In the Matter of)	
)	Docket No. 50-0219-LR
AMERGEN ENERGY COMPANY, LLC)	
)	ASLB No. 06-844-01-LR
(License Renewal for the Oyster Creek)	
Nuclear Generating Station))	June 23, 2006
)

PETITION TO ADD A NEW CONTENTION

Subject: Discussion of Corrosion Monitoring Methodologies
At Oyster Creek Nuclear Plant Dry Well

Figure 1

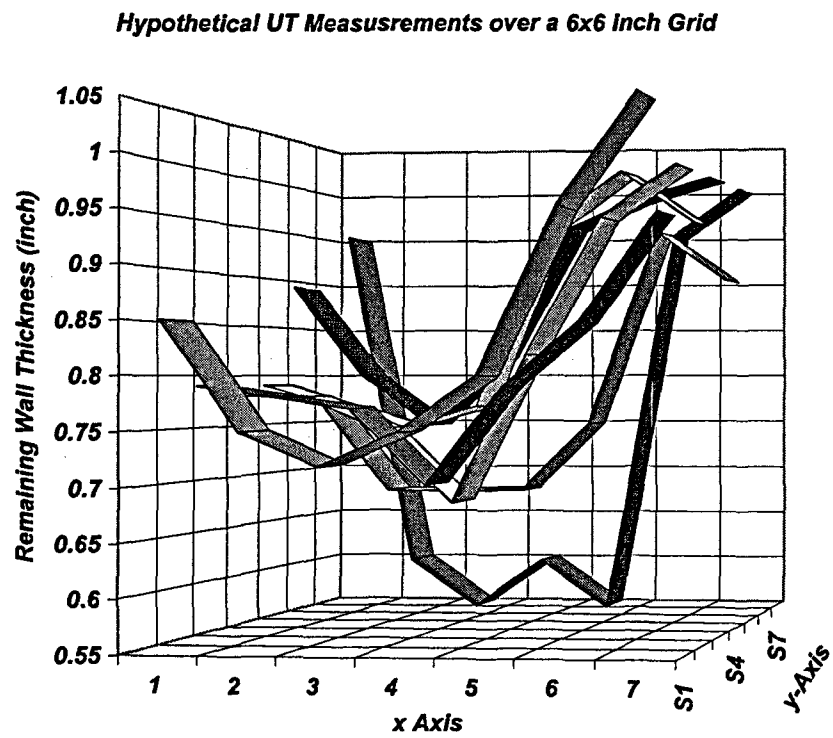
Since the actual original UT measurements were not available for a detailed statistical analysis, a hypothetical 6x6 inch grid was constructed to illustrate a point to be made here. Figure 1 shows hypothetical UT measurements in a 6x6 grid with 1 inch spacings. The average wall thickness over the grid is 0.81 inches. However, as is often the case in real life, a corrosion trough is depicted parallel to the y-axis with an average depth of 0.68 inches and a maximum depth of 0.55 to 0.60 inches. While this example is not a real life observation, it nevertheless illustrates how averages can be misleading. In this particular case, the corrosion trough exceeds the grid, and one could not tell whether corrosion would become more severe or less severe beyond the boundaries of the grid. Similarly, when Amergen talks about "isolated minimum thickness measurements", one does not know where these were recorded and whether there were others, which exceeded the average wall loss, but

Figure 2

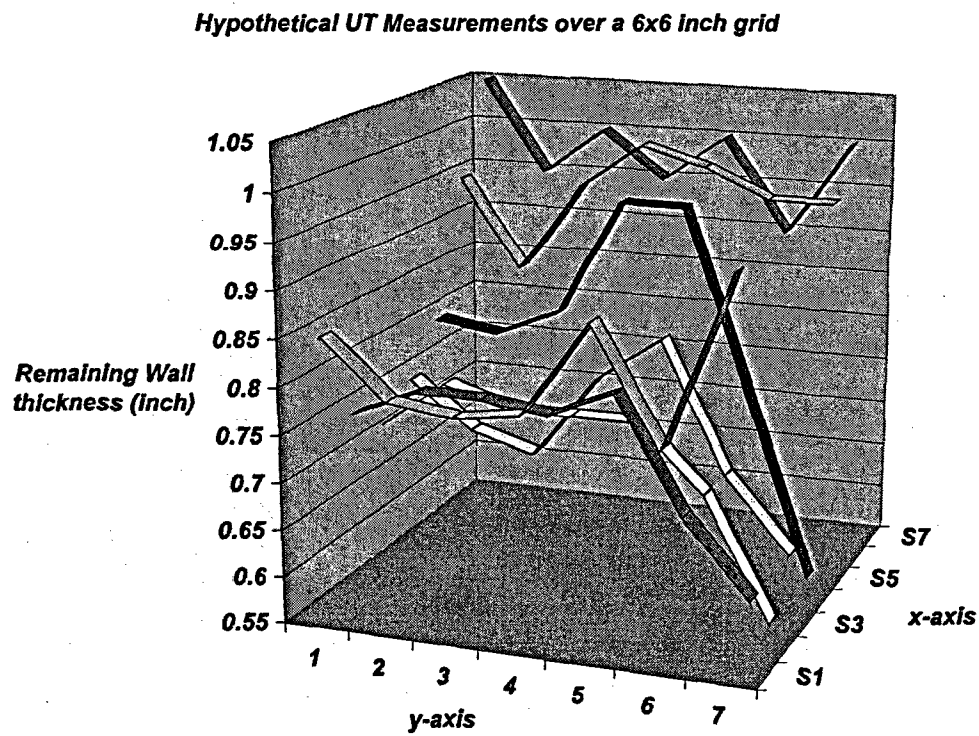
may have been above the quoted minimum wall thickness. When the same data shown in Figure 1 are plotted from a different perspective (Figure 2), conclusions may be different, but again it appears that there may be an extensive corrosion phenomenon on one side of the grid.

b. Figure 5

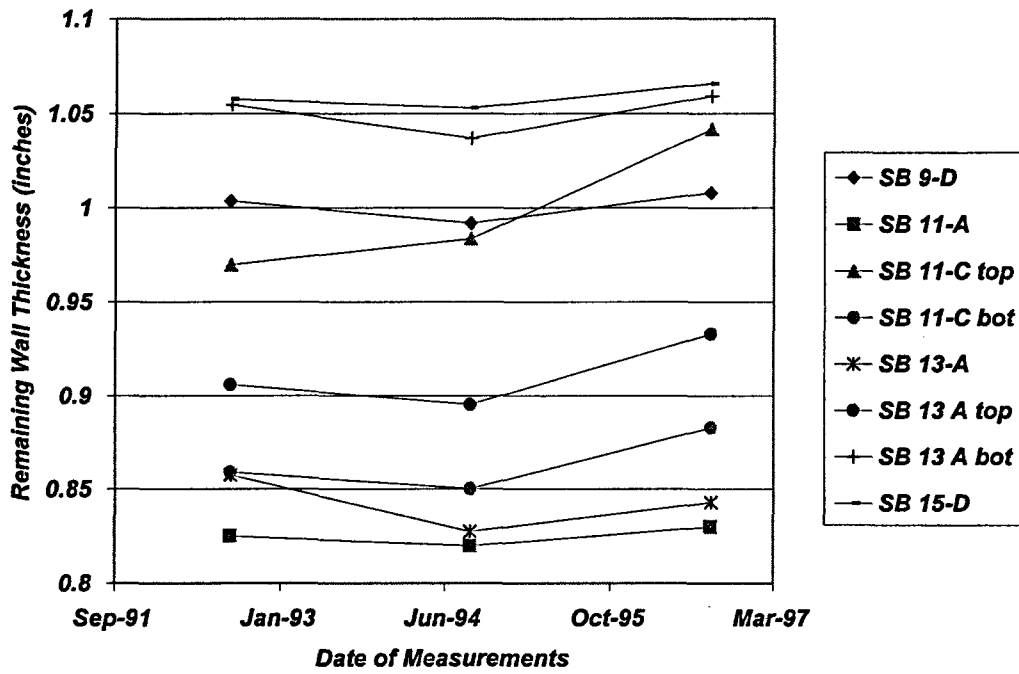
higher than the previous two. This is shown in Figure 5. However, a statistical Analysis of Variance (ANOVA), Figure 6, shows that there is no significance to these variations from date to date if the data are amalgamated. However, the differences from location to location are indeed very significant. On the basis of these data AmerGen concluded that the corrosion was arrested following the application of the epoxy coating. It is probably correct that *on average* the corrosion was significantly slowed or even arrested during the four years covered by the measurements. Whether the extreme corrosion rates were also similarly affected remains an open question. Nevertheless, it would be logical to expect that corrosion slowed down following the application of the coating, at least for a period of time. It is, however, stretching credulity to assume that such protection would last in excess of the stated lifetime of the coating, which was specified as 8 to 10 years.

Figure 7

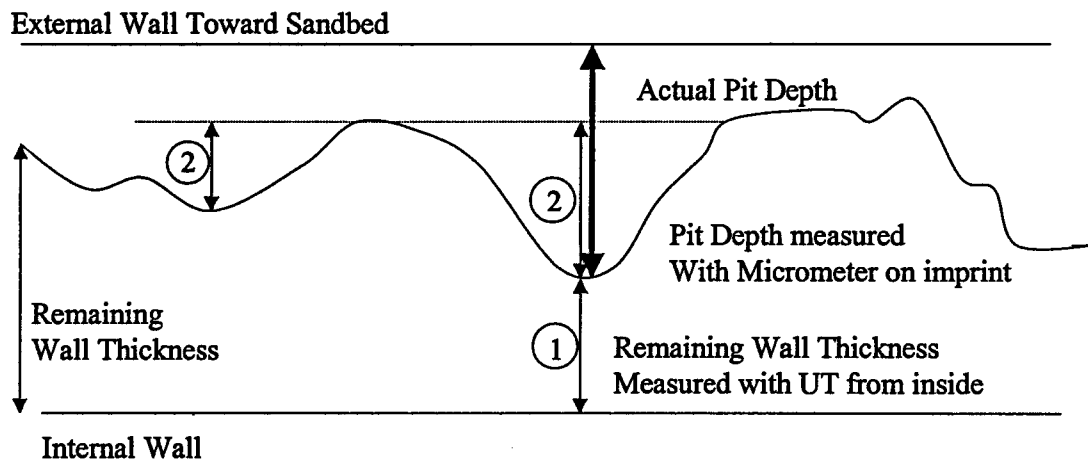
Figure 7 is a schematic of what I understand was done to arrive at a representative remaining wall thickness in the former sandbed region in order to subsequently perform GE type vessel integrity calculations. First: UT measurements were taken from the inside as described earlier. Second: an imprint (or cast) was taken from the

outside in order to characterize the roughness of the corroded surface in addition to the UT measurements. The roughness is also characterized as "dimples". The depth of the dimples was measured from the imprint by means of a micrometer. Thus, Figure 7 shows the UT measurement (1) from the inside, which characterizes the remaining wall thickness. Second, the dimple depths were measured (repeatedly) and averaged (2). This average was added to each UT measurement. Third, a characteristic average dimple depth was determined and used as a global average to be used in all areas where imprints were not available, or where such were performed in a reduced fashion. The reason for this procedure is not entirely clear, other than hopefully arriving at a representative average, which could be the basis for the integrity calculations.

As can be seen from Figure 7, the first location: if the average dimple depth is added to the UT remaining wall thickness, and then a global average dimple depth is being subtracted from the result, the actual pit depth may be reduced. In the second location the actual average pit depth may be increased by this procedure.

Figure 8

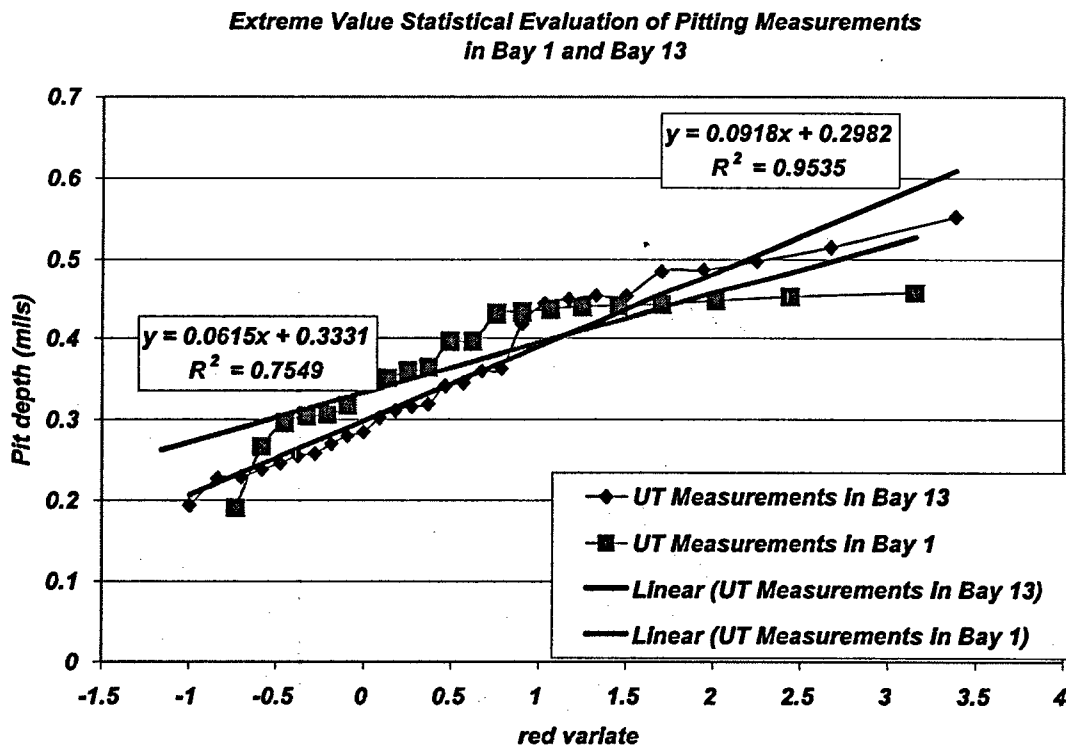
Figure 8 shows the extreme value statistical evaluation of the UT Measurements in Bays 1 and 13. It can be seen that worst case penetrations can be predicted to be of the order of 550 to 600 mils, or dangerously close to the criteria for the remaining local wall thickness of 490 mils. Hence, predictions of this nature, which in the case of Bay 13 are reasonably accurate, ($R^2 = 0.95$), are considerably less optimistic than those of GPU Nuclear.

Figure 9

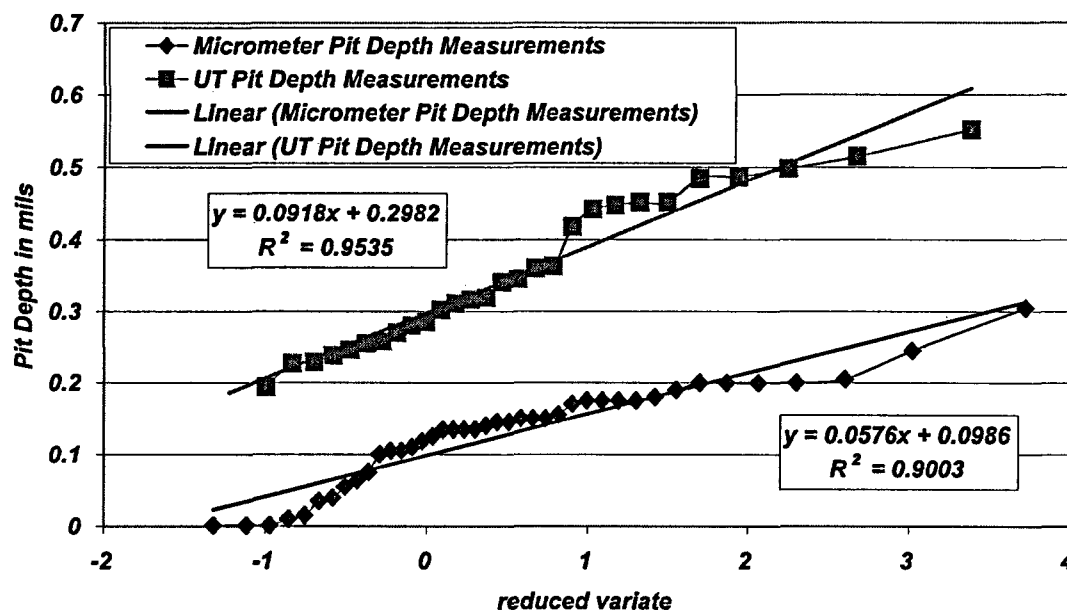
Figure 9 shows a comparison of the measurements in Bay 13 of the UT remaining wall thickness and the dimple depths. The correlations are reasonably good. The prediction for the most severe dimple depth is about 300 mils, or 50% larger than the average used by GPU Nuclear, and more in line with the use of 2 standard deviations.
